RE: Revised Tentative Order - Waste Discharge Requirements and Water Quality Certification for the Santa Clara Valley Water District and U.S. Army Corps of Engineers to implement, Upper Berryessa Creek Flood Risk Management Project, Santa Clara County

Upper Berryessa Creek looking downstream from the creek crossing at Los Coches

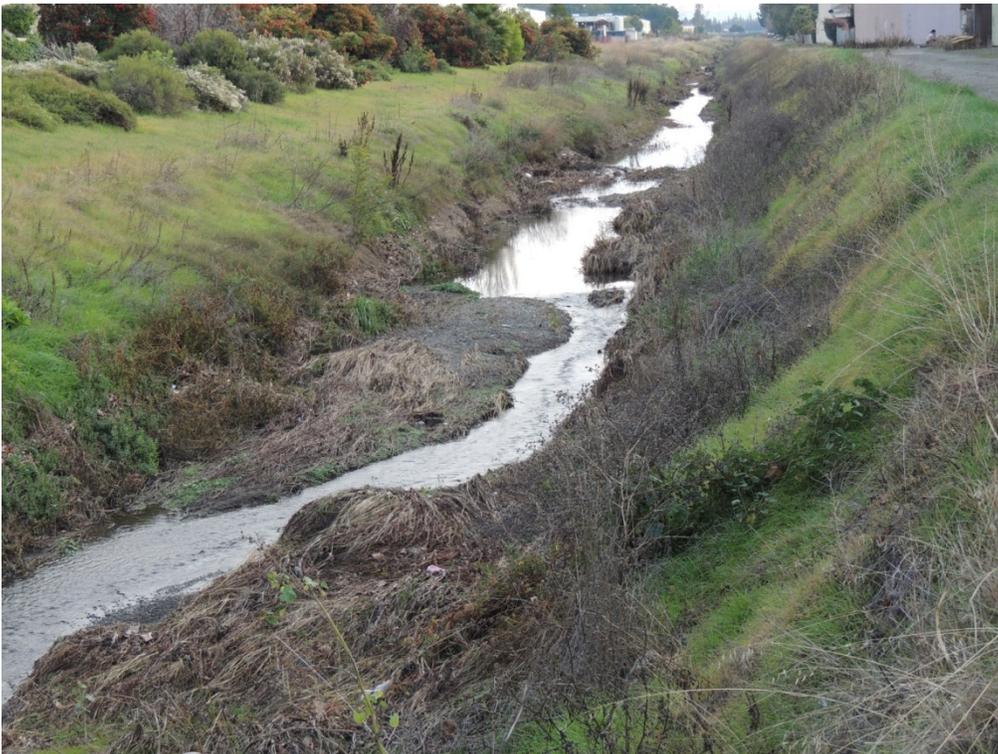
The finding discusses naming conventions of the National Wetlands Inventory for mapping wetlands. The discussion mentions that significant portions of Upper Berryessa Creek are riverine wetlands, and lists features such as inset

floodplain within the current channel. The photos below, looking upstream and downstream from the creek crossing at Los Coches, December 4, 2016, show evidence of cattail growth in the creek, development of inset floodplains, and use of the creek by waterfowl.
